Riverside Energy Park

Applicant's responses to Written Representations

8.02.14

June 2019

Figure 2.1: Extract from Land Plans (Rev 1)

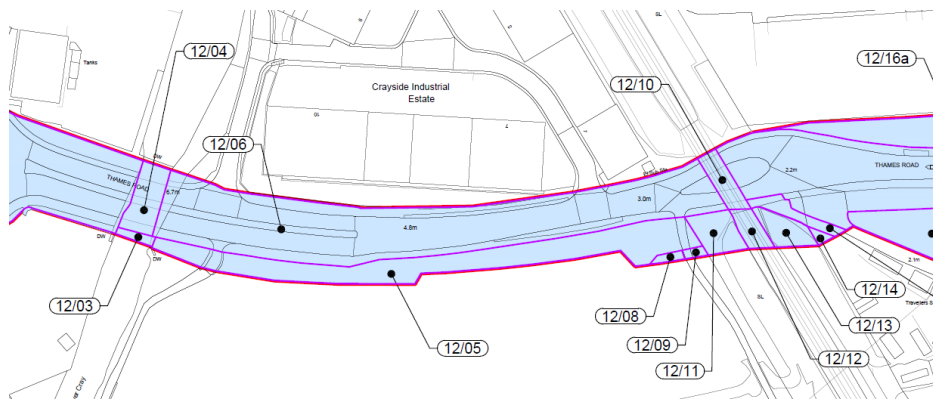
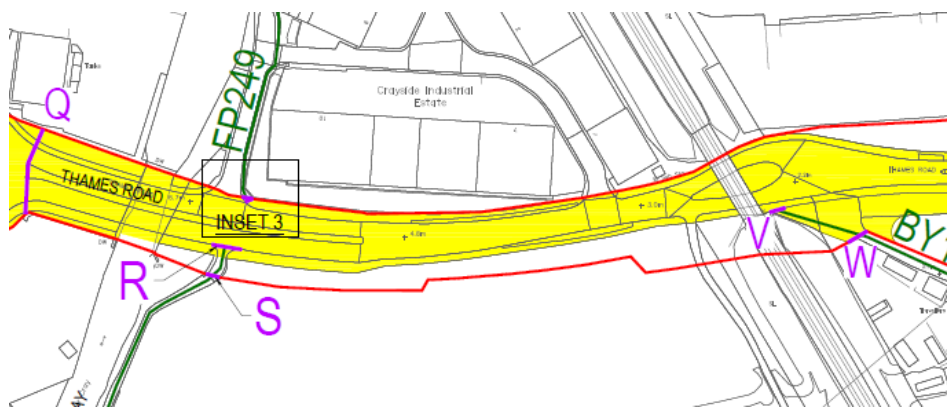
South of Thames Road (Highway land): 12/05 & 12/08

2.3.138 The extent of Parcel 12/05 required for the works was reduced by the Applicant in its submission for Deadline 2, see the changes to the Land Plans since the time of the original submission (2.1, **APP-007**) and (2.1, **REP2-003**) submitted at Deadline 2. This land was removed from the Application boundary following further landowner engagement and further investigation by UKPN. However, for the avoidance of doubt, it is noted by the Applicant that the public highway does not extend to the full width of parcel 12/05 as shown in the extracts in Figures 1 and 2 below. The Applicant's boundary is intended to generally incorporate only the width to existing highway street lighting which lies outside the public highway according to plans provided by LBB.
